Bridge 610 (N.E.P. 447.76)
Dunkirk-Fredonia Int. ramp over I-490
(Bridge repairs accepted)

New York State Thruway Authority FINAL SHOP DRAWING REVIEW	
<input checked="" type="checkbox"/> Approved <input type="checkbox"/> Approved As Noted <input type="checkbox"/> Approved For Revision No. _____	By: <i>[Signature]</i> Date: 7-1-78

TA 97-288 D212338
BRIDGE LOCATION #10, MP 467.74
DUNKIRK-FREDONIA INT. RAMP OVER I-90

ITEM: 25690, 540110 REPAIR OF STRUCTURAL STEEL
VEEDER CONSTRUCTION CORP.
DRAWING NUMBER: BR10A2

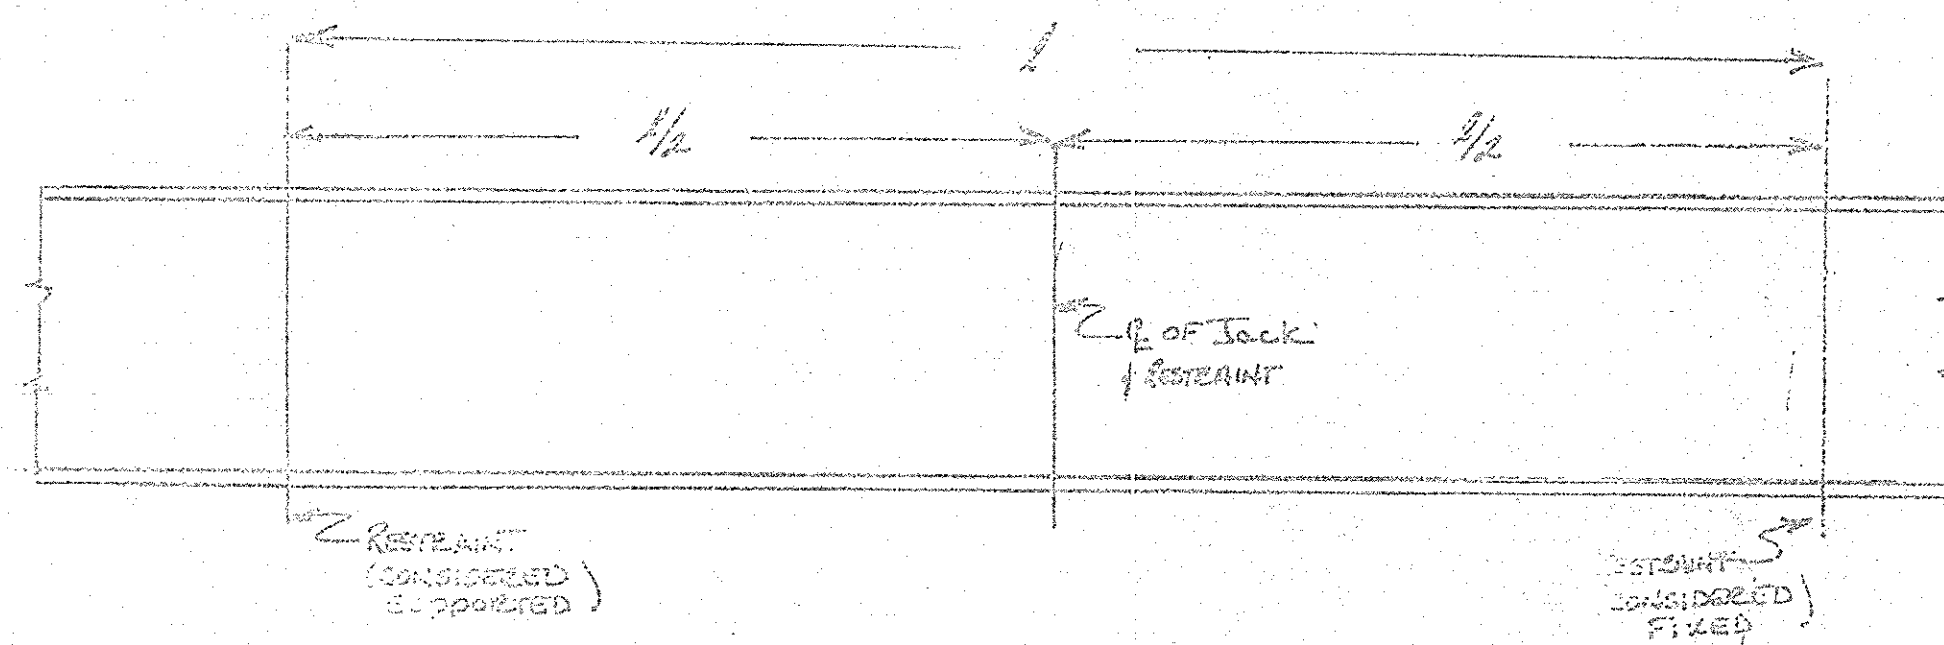
- 1) Girders straightened with heat patterns & jacks.
- 2) Removed and replaced rivets with A325 fasteners at third intermediate connection plate.
- 3) Removed and replaced second intermediate connection plate.
- 4) Ground out scrapes on bottom flange at point of impact.

- 1) No heat patterns required.
- 2) Removed and replaced rivets with A325 fasteners at second and third intermediate connection plates.

Bridge #9 (M.T. 443.69)
Sturgeon Point Rd. over I-90
(Bridge repairs accepted)

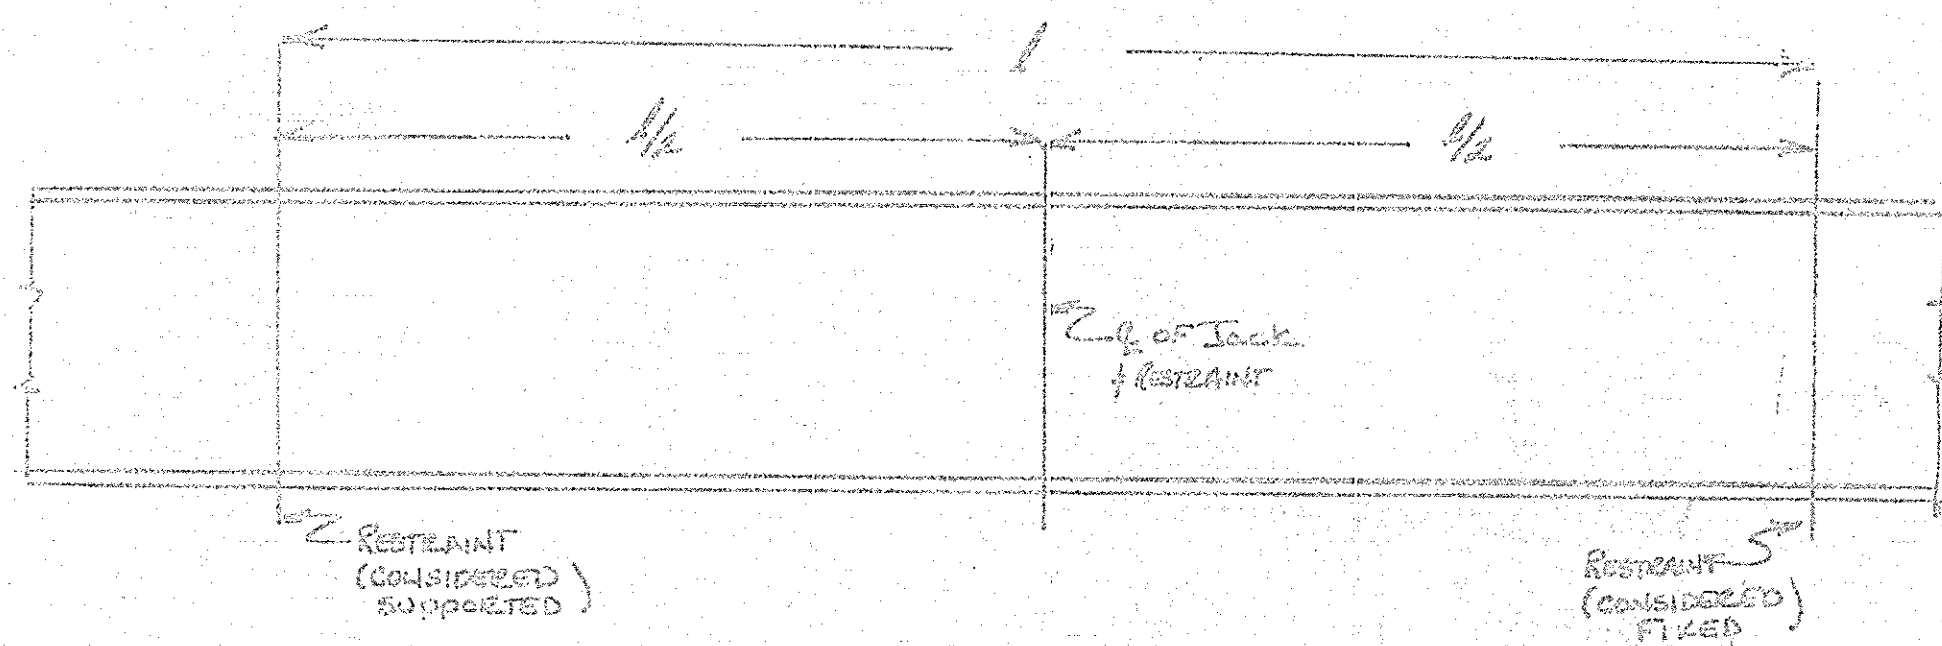
- 1.) Girder straightened with heat patterns & jacks.
- 2.) Removed and replaced Pier #1 and first intermediate connection plates.
- 3.) Repair crack at first intermediate connection plate (Passed Ultrasonic inspection test).
- 4.) Ground out scrapes on bottom flange at point of impact.

- 1.) No heat patterns required.
- 2.) Removed and replaced rivets with A325 fasteners at first and second intermediate connection plates.

New York State Thruway Authority	
FINAL SHCP DRAWING REVIEW	
<input checked="" type="checkbox"/> Approved <i>CT</i> <input type="checkbox"/> Approved As Noted <input type="checkbox"/> Approved For Revision No. _____	
By: <i>WAT</i>	Date: <i>9-1-98</i>

Bridge #8 (M.P. 417.27)
Depew Int. Ramp over I-190
(Bridge repairs accepted)

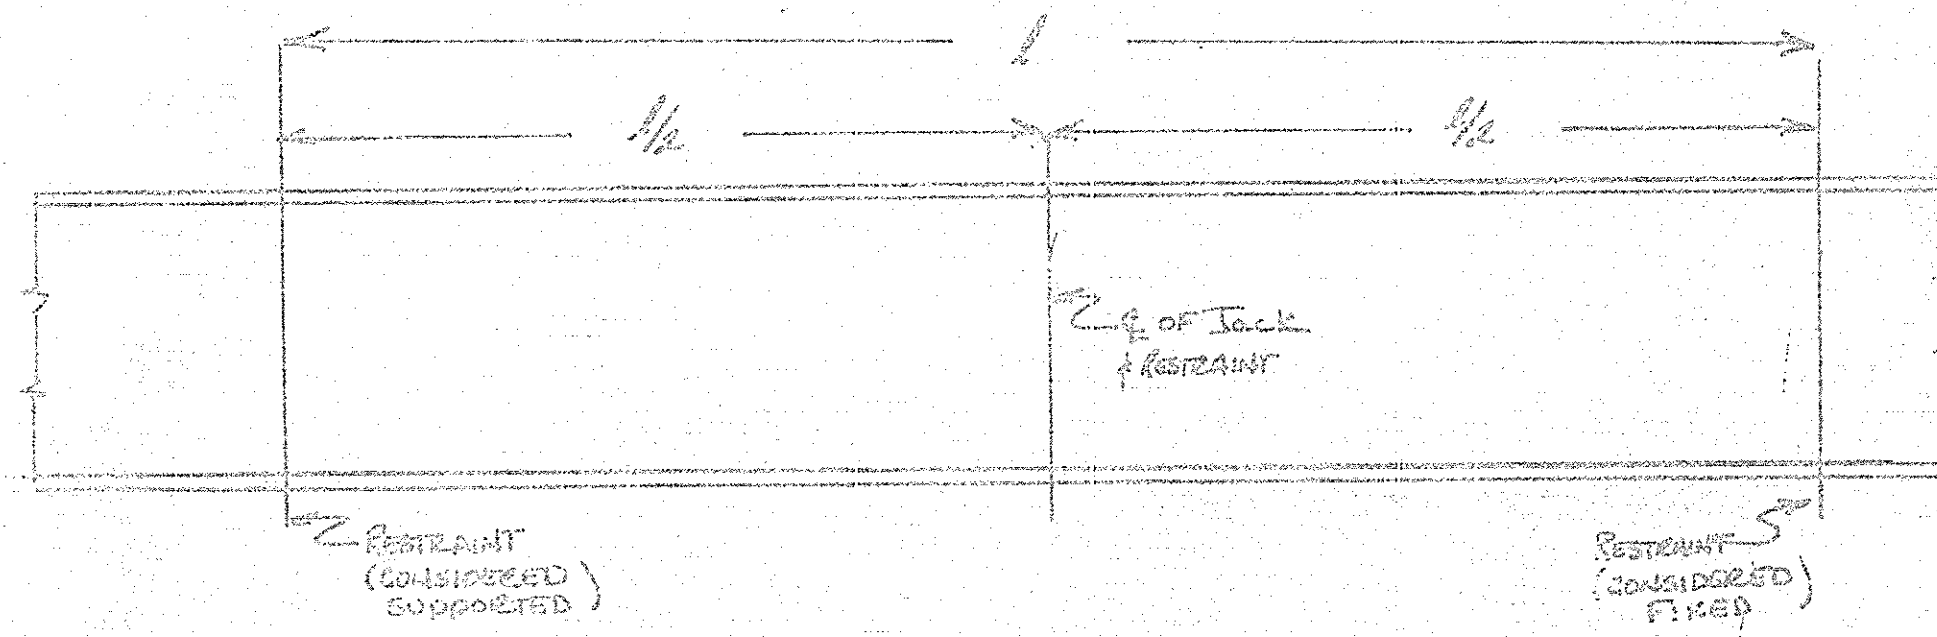
- 1.) Girder straightened with heat patterns & jacks.
- 2.) Removed and replaced second intermediate connection plate.
- 3.) Removed and replaced a 32" section of cover plate at point of impact (Passed Ultrasonic inspection test).

- 1.) No heat patterns required.
- 2.) Removed and replaced rivets with A325 fasteners at first and second intermediate connection plates.

New York State
Thruway Authority
FINAL SHOP DRAWING REVIEW

☒ Approved
☐ Approved & Noted
☐ Approved For Revision No. _____
